Addendum

Global technical regulation No. 9

PEDESTRIAN SAFETY

Corrigendum 1

Figure 12:..."

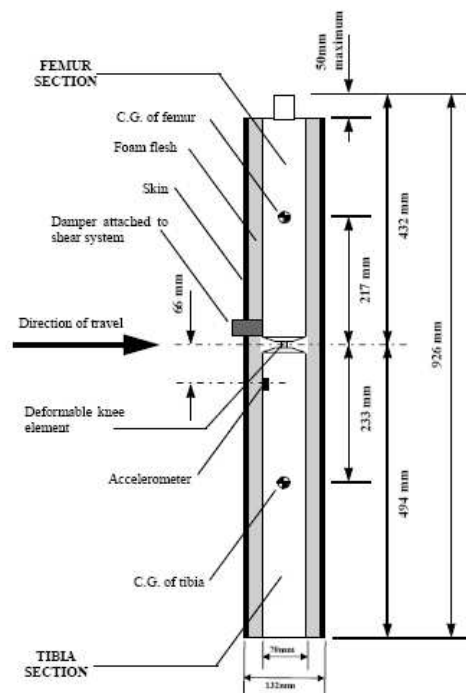
Paragraph 6.3.1.1.7.2., figure 12, replace by the following:

"6.3.1.1. ... test mass of 13.4 ± 0.2 kg (see Figure 12). Dimensions of the various parts are detailed in Figure 12."
